**REZONING, PUD, & SUBDIVISION
STAFF REPORT****Date: July 7, 2005**

<u>DEVELOPMENT NAME</u>	Hillcrest Commons Subdivision
<u>SUBDIVISION NAME</u>	Hillcrest Commons Subdivision
<u>LOCATION</u>	Northeast corner of Hillcrest Road and Johnston Lane, 150'± South of Chandler Street.
<u>CITY COUNCIL DISTRICT</u>	District 6
<u>PRESENT ZONING</u>	R-1, Single Family Residential; B-1, Buffer Business; and B-2, Neighborhood Business
<u>PROPOSED ZONING</u>	B-1, Buffer Business; and B-2, Neighborhood Business
<u>AREA OF PROPERTY</u>	5.6± acres
<u>CONTEMPLATED USE</u>	Office Space and Retail It should be noted, however, that any use permitted in the proposed district would be allowed at this location if the zoning is changed. Furthermore, the Planning Commission may consider zoning classifications other than that sought by the applicant for this property.
<u>TIME SCHEDULE FOR DEVELOPMENT</u>	Immediate
<u>ENGINEERING COMMENTS</u>	Must comply with all stormwater and flood control ordinances. Any work performed in the right of way will require a right of way permit. The existing stormwater detention, shown on proposed lot 2, must be maintained to the original design capacity and function. Depending

SITE PLAN

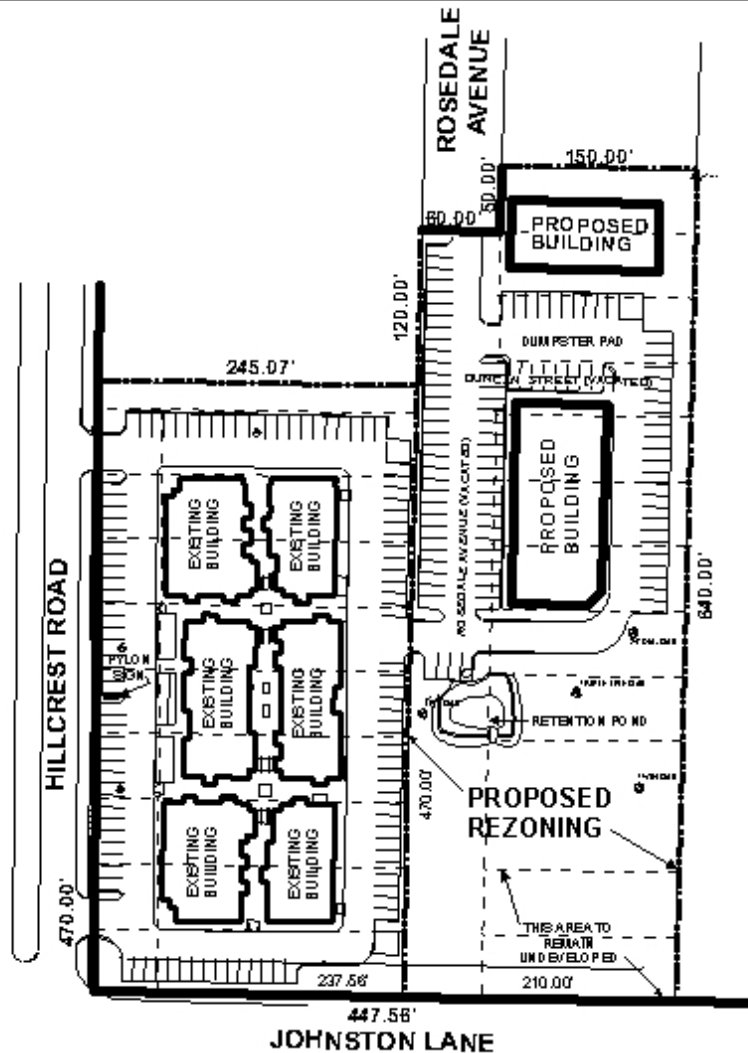
The applicant is requesting Planned Unit Development (PUD) approval for multiple buildings on multiple building sites, and shared access and parking. The applicant proposes two points of access from Hillcrest Road onto proposed Lot 1, and no points of access to any street for proposed Lot 2; Lot 2 would have a single point of ingress and egress, only onto Lot 1. The benefit of this arrangement is that Johnston Lane, a primarily residential street, will be shielded from this traffic; however, this means 192 parking spaces would be served by only two points of access to a public street; and 63 of those would have only a single point of egress from Lot 2. As this poses concerns about internal circulation, the final site plan should show two points of access between proposed Lots 1 and 2.

While proposed Lot 2 does have the minimum required street frontage, there would be no curb cuts to Johnston Street. It should be noted that any additional curb cuts would require a new subdivision and PUD application. The southeastern part of the site, along the Johnston Street frontage, also contains a note reading: "This area to remain undeveloped." This would preserve a significant wooded area and serve as a buffer for adjacent residential properties.

A portion of the plat illustrated as vacated right-of-way has not yet been vacated (100' of Rosedale Avenue, extending north from the former Duncan Lane right-of-way); however, the applicant is in the process of applying for vacation of this right-of-way. Completion and documentation of this vacation will be required before recording the final plat or issuance of any permits.

The site fronts Hillcrest Road, a planned major street with a 100' right-of-way and Johnston Lane, which has a substandard right-of-way of 40 feet; thus sufficient dedication to provide 25 feet from the centerline of Johnston Lane should be shown on the final plat.

This application was held over from the July 7th meeting to allow the applicant time to submit revised drawings reflecting additional parking.

As revised, the site plan depicts parking, exclusive of existing parking, sufficient to comply with the parking requirements of the Zoning Ordinance. Therefore, the application is recommended for approval, per the conditions listed for Rezoning, PUD, and Subdivision.

Rezoning Based on the preceding, this application is recommended for approval, subject to the following conditions: 1) the dedication of sufficient right-of-way to provide 25' from the centerline of Johnston Lane; 2) completion and documentation of vacation of the Rosedale Avenue right-of-way, north of the former Duncan Lane right-of-way; 3) compliance with Engineering Department comments

(existing stormwater detention shown on proposed Lot 2 must be maintained to original design capacity and function); 4) compliance with Traffic Engineering comments (aisles should comply with minimum standards for two-way traffic; standard aisle width for two-way traffic is 24 feet); 5) that the site be developed in compliance with the accompanying Planned Unit Development; 6) the provision of a buffer between the site and R-1 zoned property, in compliance with Section IV.D.1 of the Zoning Ordinance; 7) full compliance with the landscaping and tree planting requirements of the Ordinance; and 8) full compliance with all municipal codes and ordinances.

Planned Unit Development Based on the preceding, this application is recommended for approval, subject to the following conditions: 1) the dedication of sufficient right-of-way to provide 25' from the centerline of Johnston Lane; 2) completion and documentation of vacation of the Rosedale Avenue right-of-way, north of the former Duncan Lane right-of-way; 3) compliance with Engineering Department comments (existing stormwater detention shown on proposed Lot 2 must be maintained to original design capacity and function); 4) compliance with Traffic Engineering comments (aisles should comply with minimum standards for two-way traffic; standard aisle width for two-way traffic is 24 feet); 5) the provision of an additional point of access between the two proposed lots; 6) area shown as undeveloped to remain in natural vegetated state; 7) the provision of a buffer between the site and R-1 zoned property, in compliance with Section IV.D.1 of the Zoning Ordinance; 8) full compliance with the landscaping and tree planting requirements of the Ordinance for the entire PUD site; and 9) full compliance with all municipal codes and ordinances.

Subdivision Based on the preceding, this application is recommended for Tentative Approval, subject to the following conditions: 1) the dedication of sufficient right-of-way to provide 25' from the centerline of Johnston Lane; 2) completion and documentation of vacation of the Rosedale Avenue right-of-way, north of the former Duncan Lane right-of-way; 3) the placement of a note on the final plat stating that access to Rosedale Avenue and Johnston Street is denied; 4) the placement of a note on the final plat stating that the site is limited to existing curb cuts; 4) the completion of the rezoning process; 5) the provision of a buffer between the site and R-1 zoned property, in compliance with Section V.A.7 of the Subdivision Regulations; 6) compliance with Engineering Department comments (existing stormwater detention shown on proposed Lot 2 must be maintained to original design capacity and function, and maintenance responsibilities should be shown on the final plat); and 7) ingress and egress easements between the lots to be shown on the final plat.
